Subject: Arkansas Nuclear One – Units 1 and 2
Docket Nos. 50-313 and 50-368
License Nos. DPR-51 and NPF-6
Additional Information Regarding Condensate Storage Tank Volume
Technical Specification Changes (TAC NOS. MA8206 and MA8207)

Response to NRC RAIs on ANO CST License Amendment Request

FIGURE 1 - ANO-1 EMERGENCY FEEDWATER SYSTEM

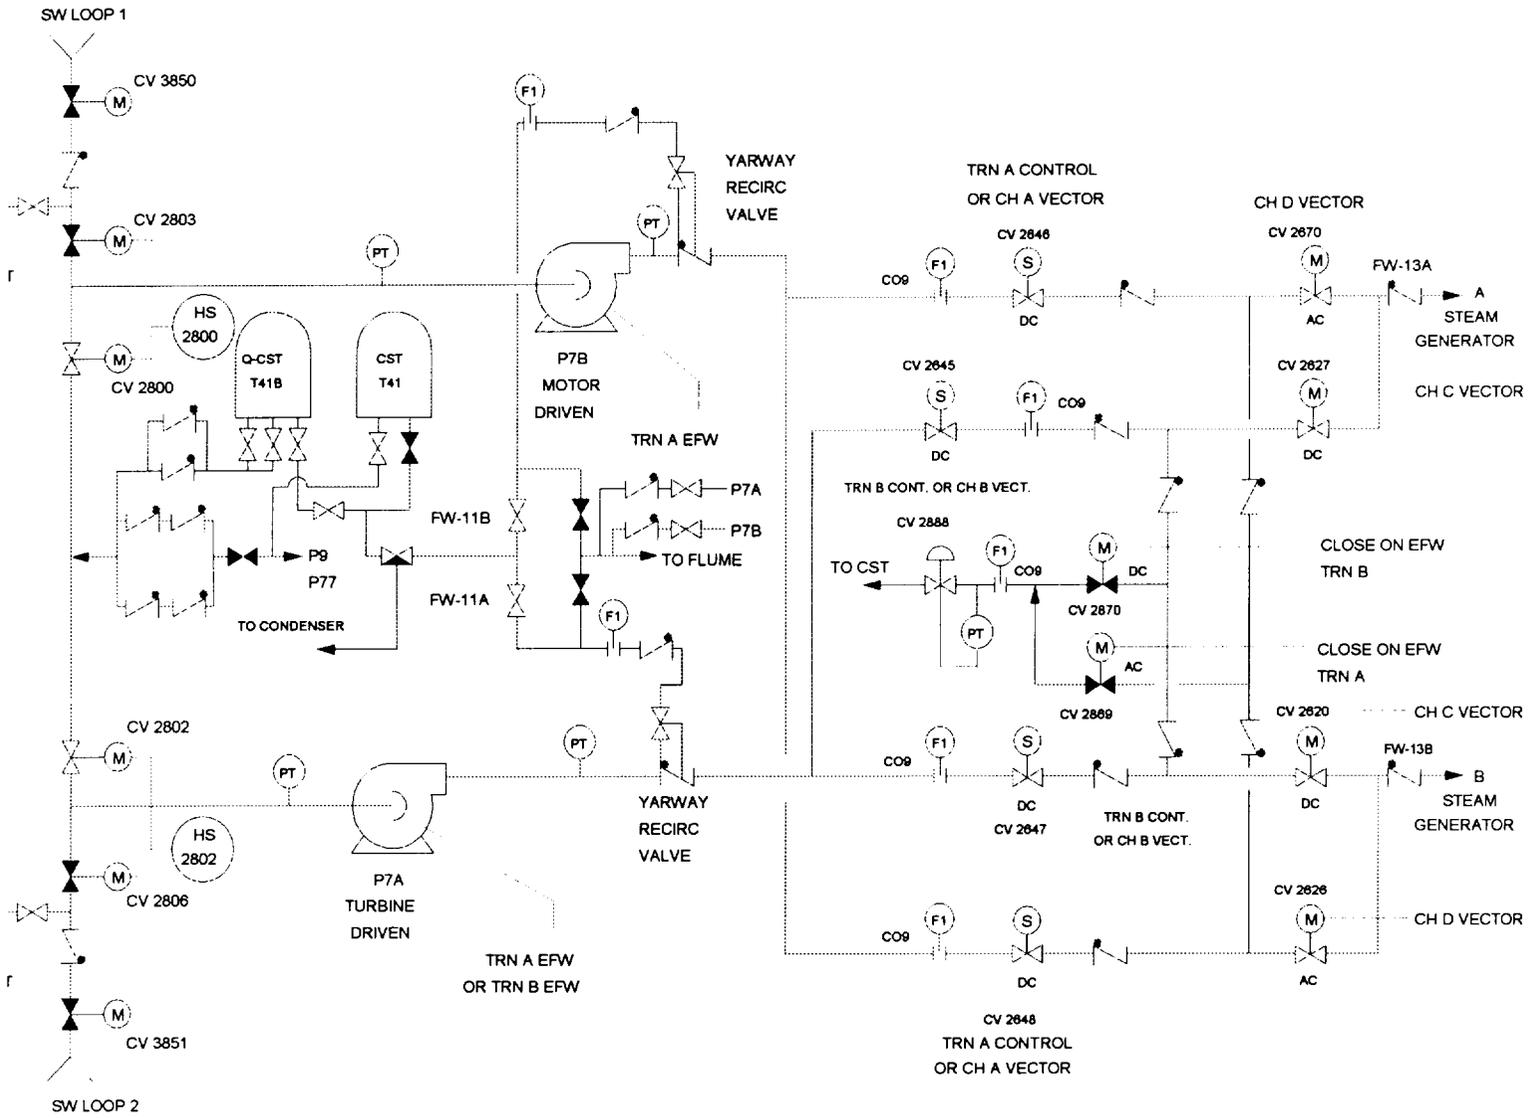
How is the flow path from the service water system to the EFW systems tested or inspected to demonstrate that they are free of blockages or silting? Are the valves needed to realign the source of auxiliary feedwater systems to the service water systems tested to demonstrate that they will be capable of performing their intended function? How often are they tested? Does the proposed TS change require changes in your inservice testing program or otherwise require additional equipment to be tested?

Are the valves needed to realign the source of auxiliary feedwater systems to the service water systems tested to demonstrate that they will be capable of performing their intended function? How often are they tested?

Water from either CST is aligned to the suction of each pump through an 8" motor operated gate valve. Water supply to P-7A is isolated by CV-2802 while CV-2800 isolates water to P-7B. These isolation valves are located in the EFW pump room and are normally open. These valves are stroked closed and open each quarter using Supplement 3, Emergency Feedwater Valve Stroke Testing, of 1106.006.

SW loop 2 supplies P-7A through motor operated valve (MOV) CV-3851 and suction supply isolation CV-2806. SW Loop 1 supplies P-7B through motor operated isolation valve CV-3850 and suction supply isolation CV-2803. SW loop and suction supply isolations to EFW are normally closed. These valves are stroked open each quarter using instructions contained in Supplement 3 of 1106.006.

Figure 1 shows that closure of CV-2802 and opening of CV-2806 and CV-3851 will align service water to P-7A. To align service water to P-7B, CV-2800 is closed and CV-3850 and CV-2803 are opened. No other valve manipulations are required.

FIGURE 2 - ANO-2 EFW/AFW One Line Diagram

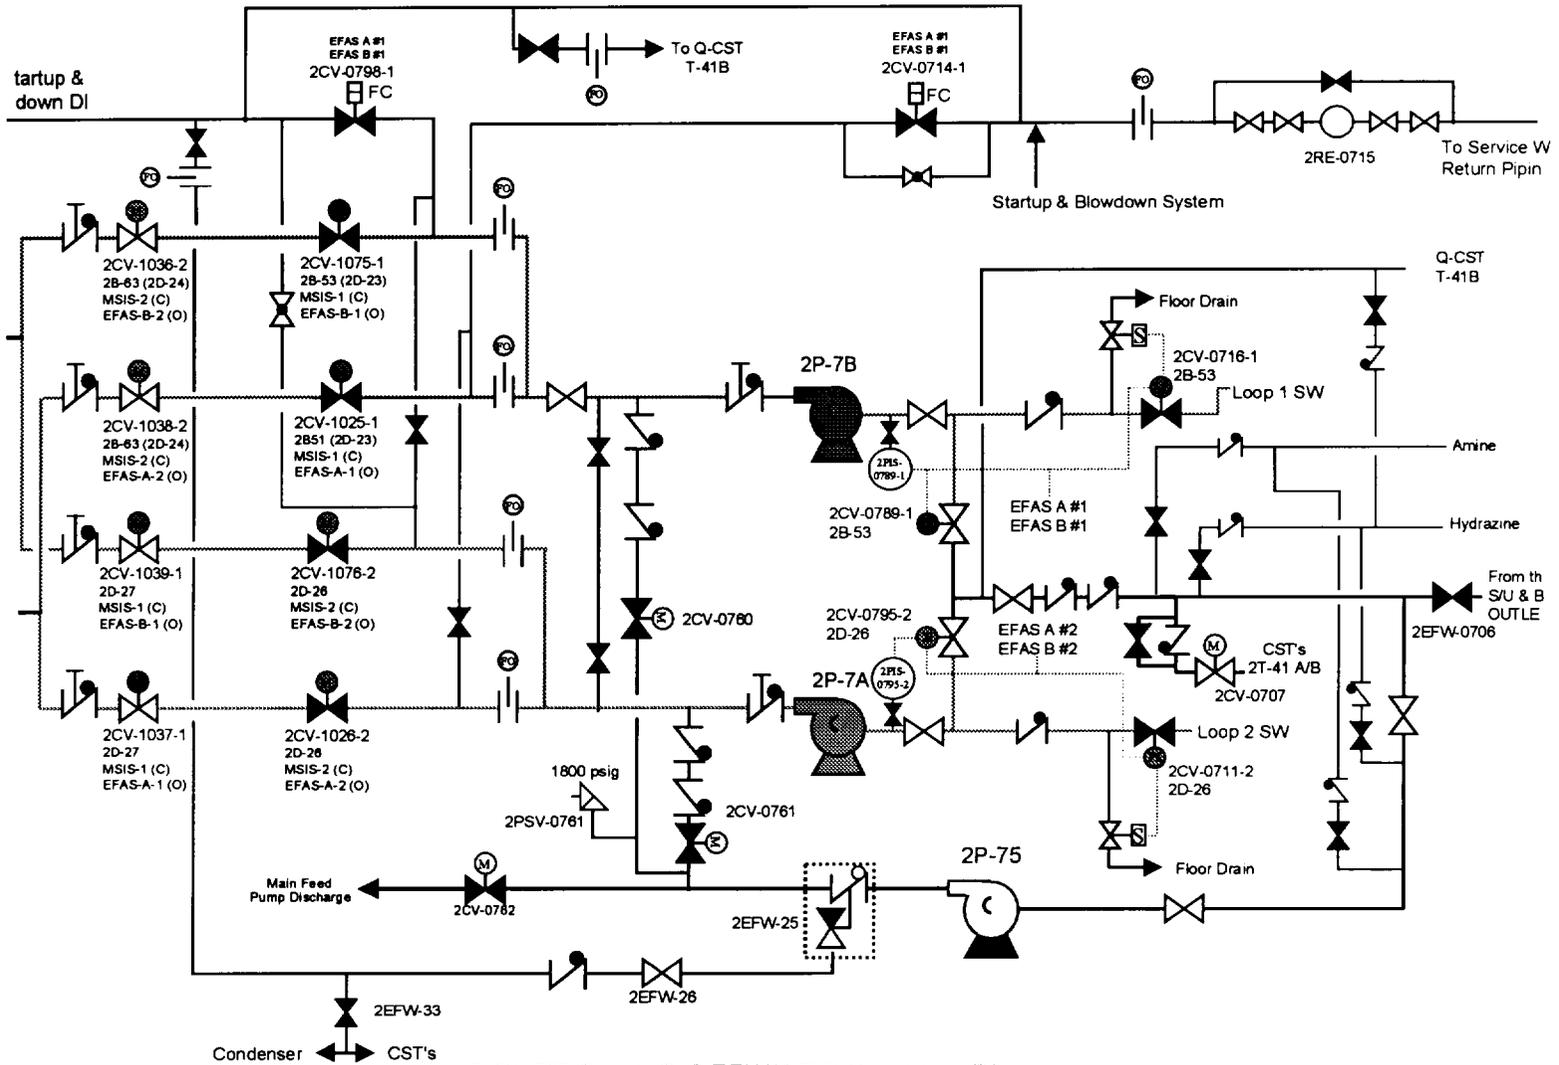
Are the valves needed to realign the source of auxiliary feedwater systems to the service water systems tested to demonstrate that they will be capable of performing their intended function? How often are they tested?

As the attached ANO-2 emergency feedwater simplified system drawing (Figure 2) reflects, opening 2CV-0716-1 and 2CV-0711-2 will align service water to the suction of the EFW pumps and closure of two MOVs (2CV-0798-1 and 2CV-0795-2) will isolate suction from either the QCST (T-41B) or the ANO-2 CSTs (2T-41A or 2T-41B). The hand switches for these valves are located on panels in the Unit 2 control room. These valves are stroke tested quarterly using instructions contained in Supplement 3, Quarterly Emergency Feedwater Valve Stroke Testing. 2CV-0716-1 and 2CV-0711-2 are stroked open and 2CV-0798-1 and 2CV-0795-2 are stroked in the open and closed directions.

- 1) A passive open safety function of manual valves 2CS-816 and 2CS-817, which when open align the QCST to the suction of the EFW pumps.
- 2) An active safety function to open check valves 2CS-844 and 2CS-845.
- 3) An active safety function to close check valves 2CS-844 and 2CS-845 unless 2EFW-802 is maintained locked closed when above Mode 4. Disassembly every refueling outage to verify operability may be used.
- 4) An active safety function to close 2EFW-1 and 2FW-801 when the QCST is aligned to ANO-2 unless 2EFW-802 is maintained locked closed above Mode 4. Disassembly every refueling outage to verify operability may be used. {NRC commitment}
